U.S. Department of Energy Review of the Lighting Research Center's New Specifier Report On Streetlights for Collector Roads

October 22, 2010

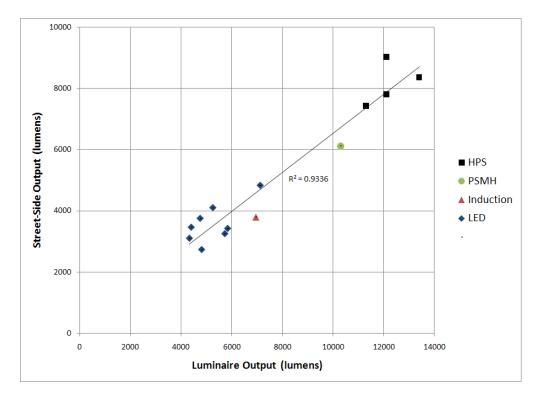
LRC commits a critical error at the outset of the study which then permeates the remainder of the report. The issue is easily visible in the figure below, which plots "street-side output in lumens" (LRC's measure of choice) against total luminaire output for the various products evaluated.

The nearly linear distribution of points in the graph reveals that the LED and induction products selected by NLPIP for this analysis were simply (and dramatically) underpowered for this application. Selection of higher powered LED and induction products appropriate for this application, which are widely available in the market, would have offered correspondingly higher luminaire output, and made possible a fair comparison with the selected HPS products.

As it stands, this basic flaw in the LRC methodology cascades through the report's conclusions and entirely undermines the general statements made about LED performance. The conclusions about LED systems needing more luminaires and poles, and consequently having much higher first costs, follow directly from this selection error and are thus baseless.
